FAIRFAX COUNTY

STAFF REPORT

APPLICATION RZ/FDP 2003-MV-059

PROPOSAL: To rezone from the C-8, R-3, HC and CRD District to the PRM, HC and CRD District to permit development of a mixed-use development to include multi-family residential uses (up to 24 units) and retail uses of 8,700 SF within a single building.

Final Development Plan

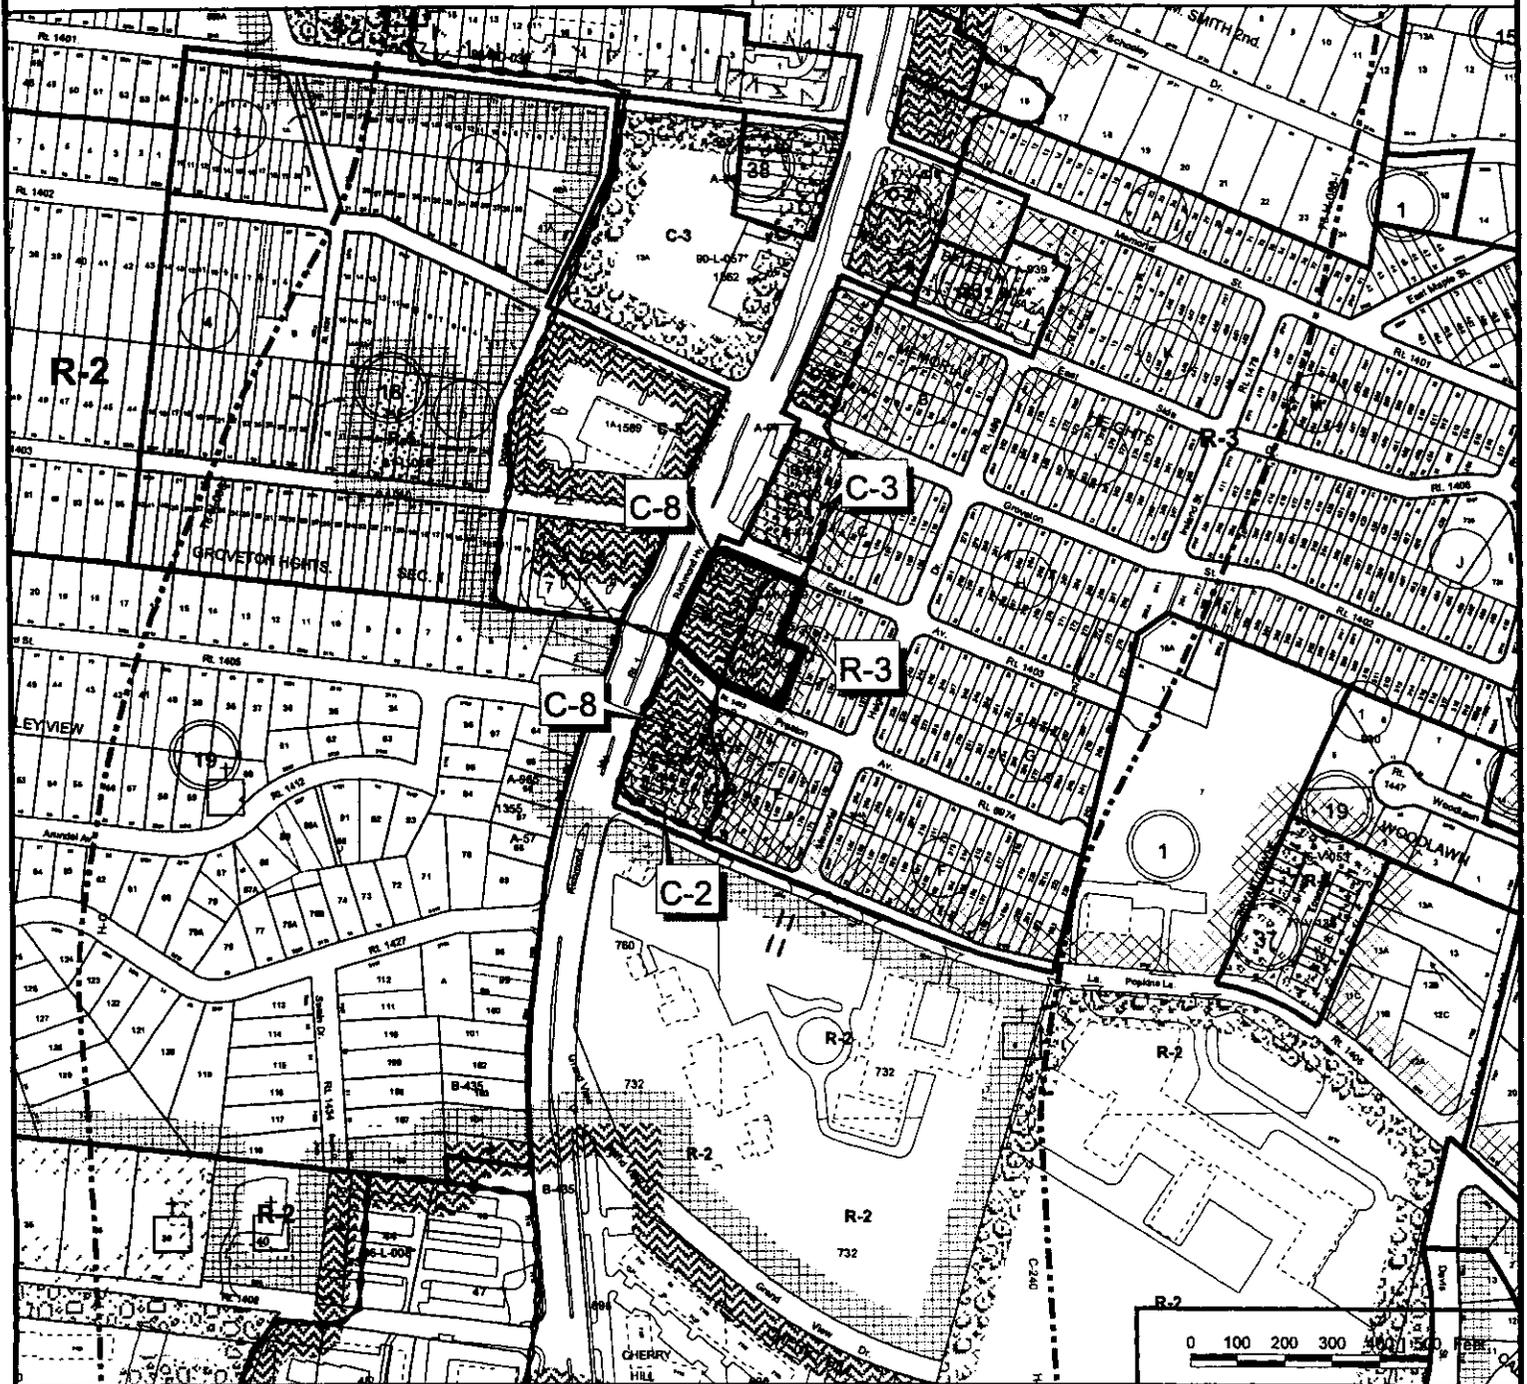
Site Layout: The CDP/FDP depicts a four-story building oriented to Richmond Highway. The first floor of the building is set back 20 feet from the proposed right-of-way (ROW) for Richmond Highway. The top three floors overhang the ground floor; these upper floors are set back 15 feet from the proposed ROW. Up to 24 multifamily units are proposed on the top three floors, while retail uses are proposed for the first (ground) floor. The proposed architecture is residential in nature. The elevations on Sheet 2 depict balconies on all four sides of the building. The proffers indicate that the building materials for the structure will be a combination of materials to include pre-cast concrete, glass, metal panels, masonry, cement panel, or stucco or brick.

Fifty-two (52) surface parking spaces are provided behind the main building and between the main building and East Lee Avenue. Twenty-seven (27) parking spaces are proposed under the four-story building. In addition, the CDP/FDP indicates that a parking deck is to be constructed over fifteen (15) parking spaces where the site abuts Preston Avenue (see the detail on Sheet 1). The parking under these structures will be secured by a gate.

The proposed concrete deck over the parking, which will be landscaped along the top perimeter, is depicted to extend out to 10 feet from the dwelling located on Parcel 131 (see Section B-B on Sheet 2). The CDP/FDP depicts a 1,440 SF freestanding building on top of this proposed parking deck. The height and use for this building is not depicted on the CDP/FDP; however, in a letter dated May 5, 2004 contained in Appendix 4, the applicant states that the building will be a multipurpose area for the residents (meeting room and/or exercise area). However, this same letter also indicates that this building could also be used as an eating establishment.

No landscaping is proposed between the site and Preston Avenue. No detail is provided to indicate what the proposed parking decks would look like along Preston Avenue. The applicant has requested a waiver of the transitional screening along that portion of the site which abuts Preston Avenue.

As noted earlier, a concrete deck is proposed to cover the parking along Preston Avenue. A 1,440 SF freestanding building is depicted on top of the deck abutting Parcel 131 of Memorial Heights. No architectural elevations of the proposed building are provided. A detail on the CDP/FDP indicates that the perimeter of the deck will be landscaped with flowering dogwoods and what appears to be medium evergreens. A letter from the applicant dated May 5, 2004 (contained in Appendix 4), states that the deck will be landscaped with potted flowering trees and will have a concrete planter around the perimeter with low level shrubbery. The proffers indicate that the applicant will landscape and design the deck to be *"an amenity to the residents of the building and/or patrons of the proposed restaurant and/or deli who might wish to eat outside."* As stated earlier, while the use for the freestanding building is not indicated on the CDP/FDP, the applicant has stated in a letter dated May 5, 2004, that this building could either be a multipurpose room for the residents or an eating establishment. This same letter states that if the freestanding building is to be used as an eating establishment, then the multipurpose building for the residents would be located within the main building. The proffers indicate that an on-site community room/exercise facility is to be provided but the location of this facility is not specified. The proffers also do not indicate how the community room/exercise facility is to be furnished.

The most recent development proposal now depicts a 1,440 SF freestanding building located 10 feet from the barrier wall in the southeastern corner of the site. The applicant proposes to use this structure as a multipurpose area for the residents (meeting room and/or exercise area) in order to provide residential amenities for the future residents of the proposed development. But the applicant has also stated in a May 5, 2004, letter that the building may be established as a restaurant. Based on the cross-section schematic provided on Sheet 2 (Section B-B), staff believes that construction of this building will have a negative visual impact on the adjacent Memorial Heights neighborhood since all of the structure's roof will likely be visible above the barrier. No architectural elevations or details have been provided to demonstrate that the freestanding building will be residential in character or that it will not appear as a large shed in contrast to the residential/retail building. Furthermore, establishing a restaurant use in this structure would likely introduce nuisance impacts such as noise, odors, glare, trash and delivery traffic, in very close proximity to the existing Memorial Heights neighborhood.

impact the existing residences across Preston Avenue. No details have been submitted which indicate what the proposed buildings and parking deck will look like along Preston Avenue and how the buildings and parking deck might impact the abutting existing single-family detached dwellings. Based on the concerns discussed above, staff finds that the proposal has not addressed the Comprehensive Plan recommendation to provide effective buffering and screening in order to protect the adjacent neighborhood.

Staff does not believe that the proposed high density mixed-use development provides a suitable interface to the surrounding low-density residential neighborhood. As noted above, the applicant proposes to locate the parking deck on the Preston Avenue property line with no setback and landscaping to provide relief. No details of what this building and parking deck will look like along Preston Avenue have been provided. No sections of the proposed building and parking deck have been provided to demonstrate how these structures might impact the existing residences along Preston Avenue. Staff is also concerned about how the proposed parking deck and freestanding building, which will be located ten feet from the shared property line with the existing dwelling on Parcel 131, will impact the house on that lot. The applicant has provided no architecture for the proposed parking deck or freestanding building. Given the mass and bulk of these structures, staff does not believe that the proposed ten feet of landscaping will adequately screen these structures from the adjacent single-family residential use.

Based on the cross-section schematic provided on Sheet 2 (Section B-B) staff believes that construction of this building will have a negative visual impact since all of the structure's roof will likely be visible above the barrier fence. No architectural elevations or details have been provided to demonstrate that the building will be residential in character or that it will not appear as a large shed in contrast to the residential/retail building. Based on the sloping topography, it is not clear how much of this structure will be visible from residences across Preston Avenue. Establishing a restaurant use in this structure could potentially introduce nuisance impacts such as noise, odors, glare, trash and delivery traffic, in very close proximity to the existing neighborhood.

FIGURE 17

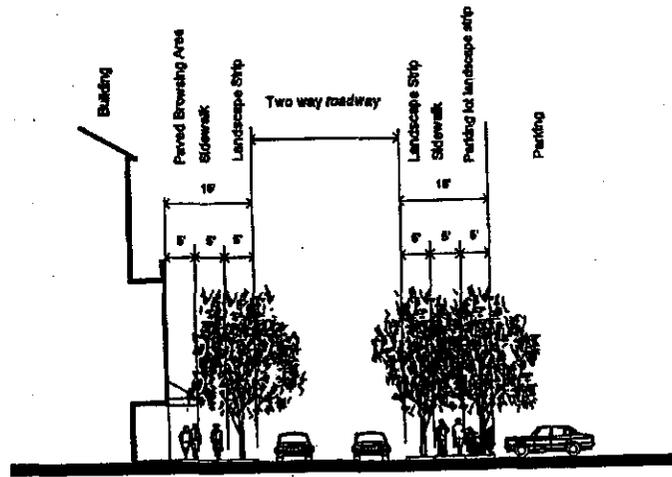
Landscape Corridor: The applicants are providing a minimum of a 10 foot Planting Strip (actual width varies from 10 feet to 16 feet) as shown in Figure 17 of the Richmond Highway Corridor Area portion of the Mount Vernon Planning District section of the Comprehensive Plan. The applicants propose to request permission from VDOT to grass and plant within the area proposed to be dedicated

FIGURE 18

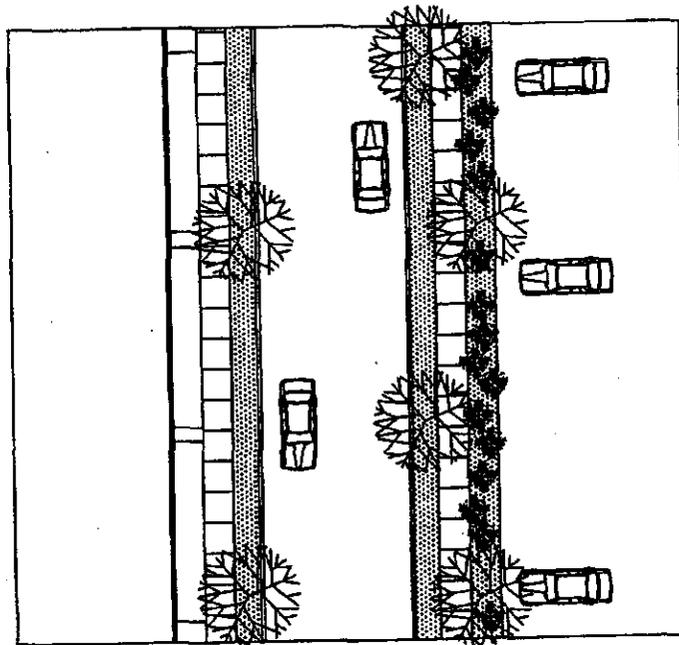
As depicted in Figure 18, on other streets that intersect Richmond Highway and are within the Richmond Highway Corridor area, a 15' total landscape corridor width should be provided and comprised of:
